M1 Junction 15
Northampton Rail Freight Interchange

Stage 1 Road Safety Audit

March 2018

Figure 2 – Location of problems identified within this audit;
A45 north of M1 J15

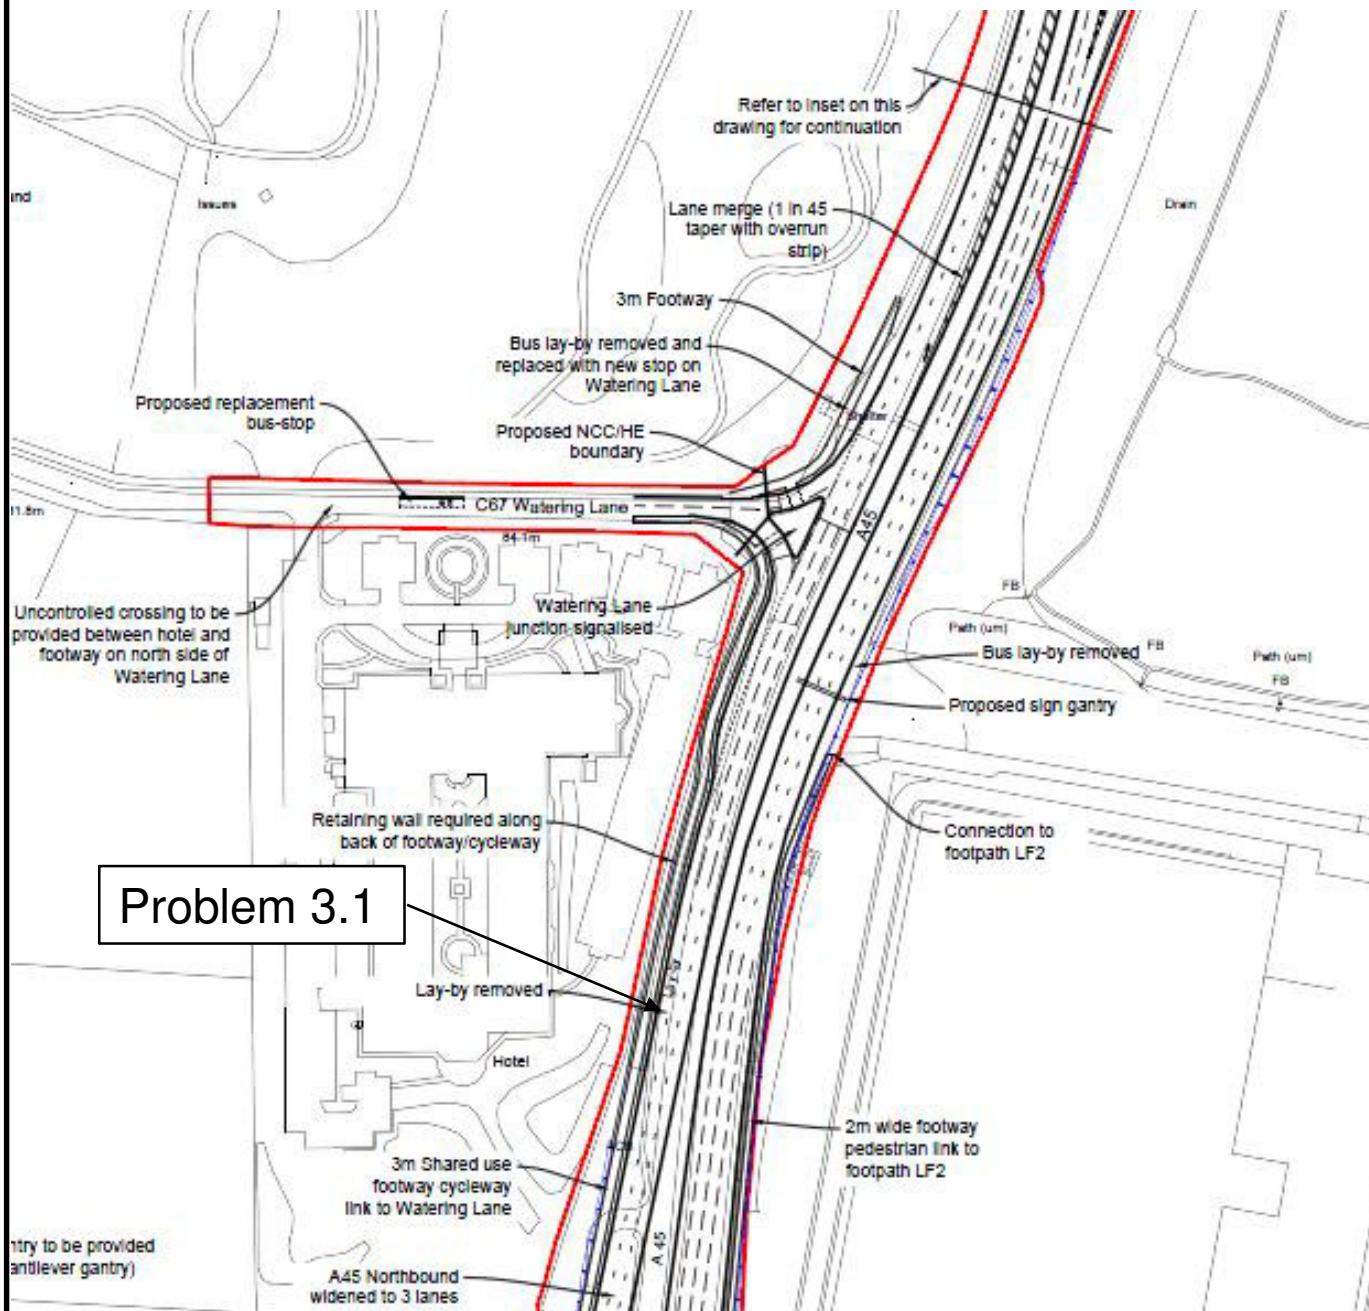
Location: Existing lay-by on A45 (N) (Figure 2)

Summary: The lay-by is heavily used by HGVs, hence it is unknown what would happen to the displaced demand.

The lay-by, which is proposed to be removed, is heavily used by HGV drivers as witnessed during the site visit. There is no reference to the facility being replaced, hence it is unknown where displaced vehicles would attempt to park. HGV drivers could be tempted to park on Saxon Avenue on the exit from the roundabout and surrounding roads for example, which could create conflict with passing vehicles.

Further information is required with regards to the removal of the lay-by, to determine if any alternative solutions have been considered to prevent any inappropriate HGV parking.

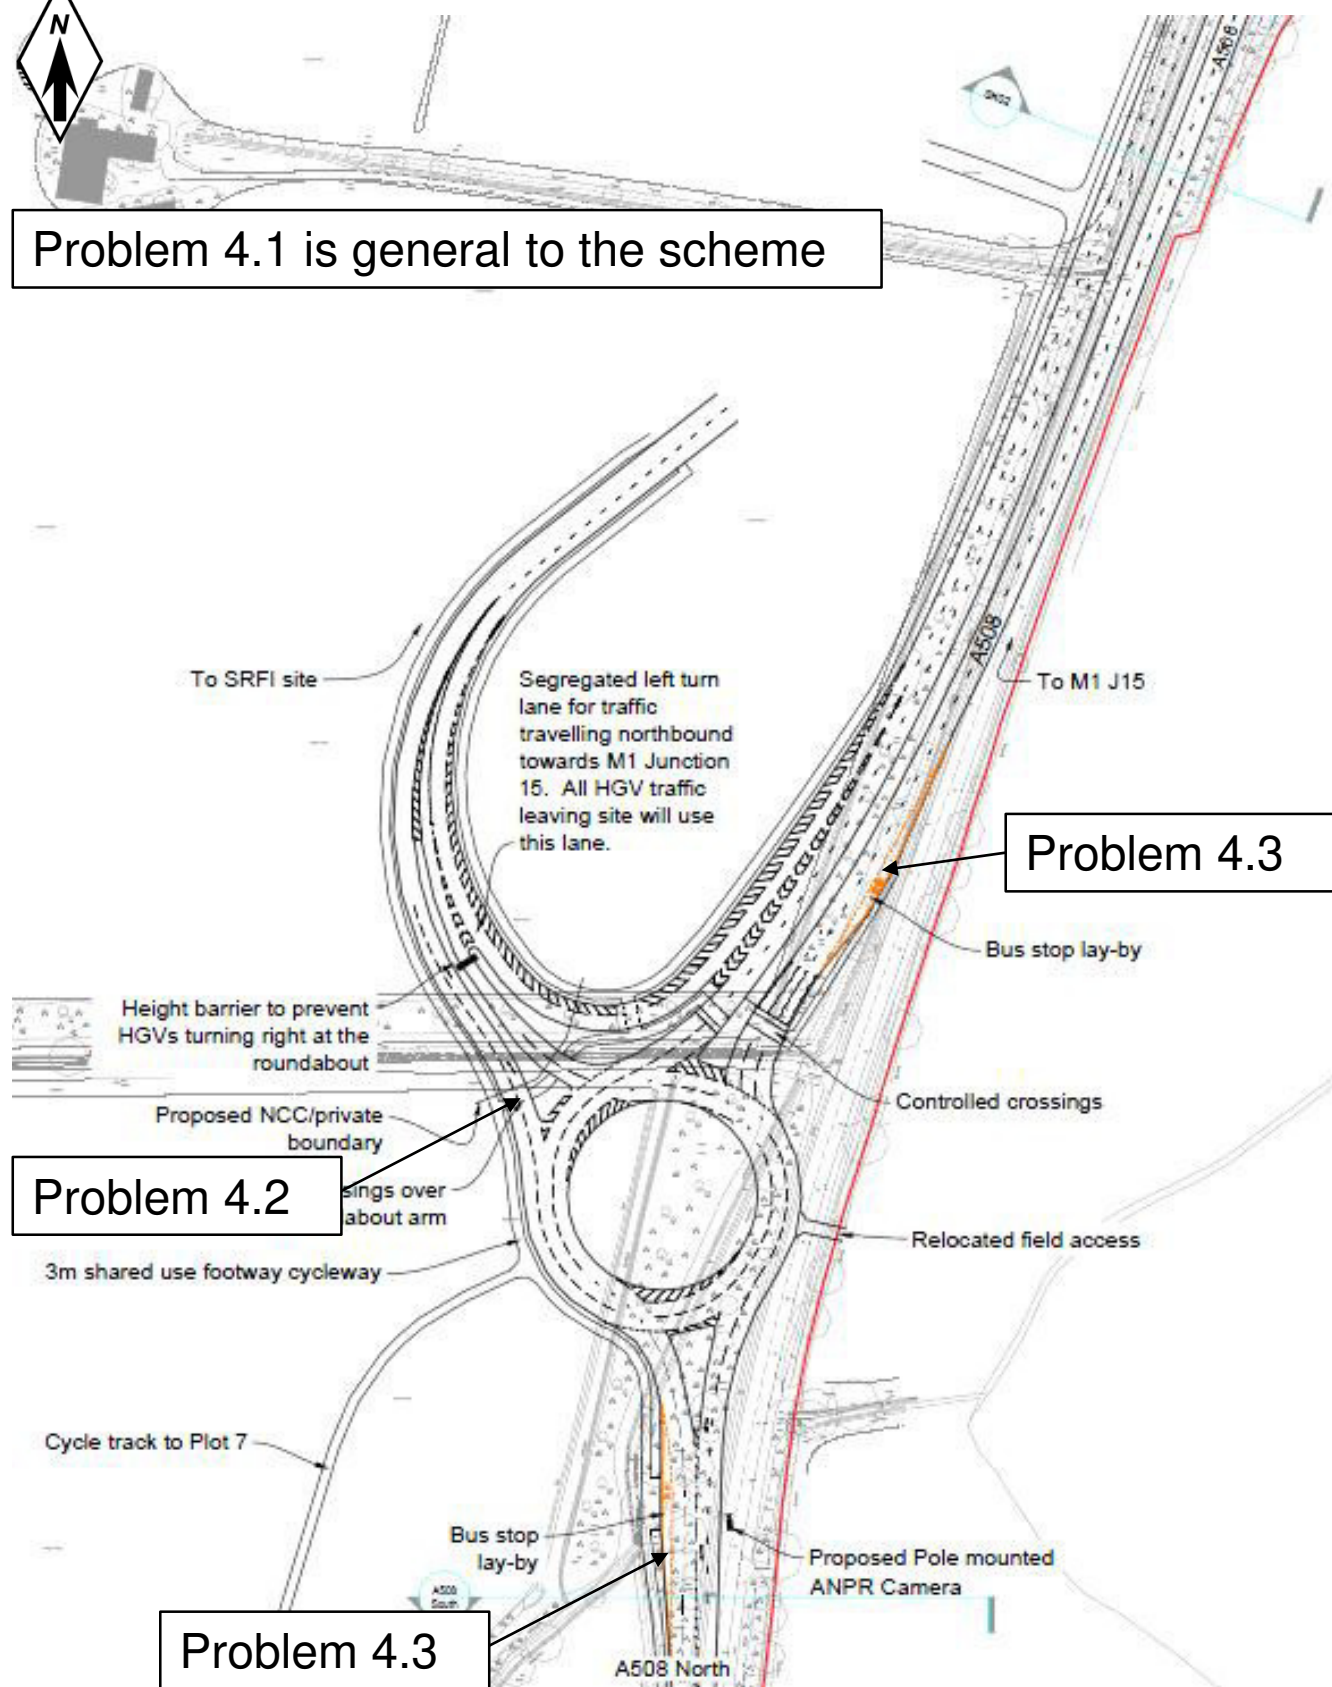
Summary: Uncontrolled crossings provided on potentially busy exit from roundabout.

The crossing facility provided over the site access arm is proposed as an uncontrolled crossing. However, the access will potentially be busy during peak times, and the exit from the roundabout is provided with two lanes merging to one within the site. This could make it difficult for pedestrians to cross the carriageway and predict vehicle movements exiting the roundabout. This is exacerbated by the provision of two lanes allowing access to the site around the roundabout.

Summary: Provision of bus stop close to the roundabout could create confusion.

The proposals include bus stops provided on both the northbound and the southbound A508 approaches to the roundabout. The northbound bus stop in particular is provided close to the roundabout and is also provided in addition to a flare from one lane to

two lanes. This results in a potentially confusing layout, as a bus pulling into the bus stop, could be followed by a car, expecting it to turn into the site, for it to suddenly stop. This could potentially lead to shunt type collisions.

Similarly, the southbound bus stop could restrict visibility to and from pedestrians using the pedestrian crossing.

Assuming pedestrian movements across the site access arm would be low, it could be beneficial to provide a signal controlled facility on the basis that it should not prejudice the capacity of said junction.

The bus stops should be located at a suitable distance away from the roundabout to prevent any confusion for motorists at the roundabout.
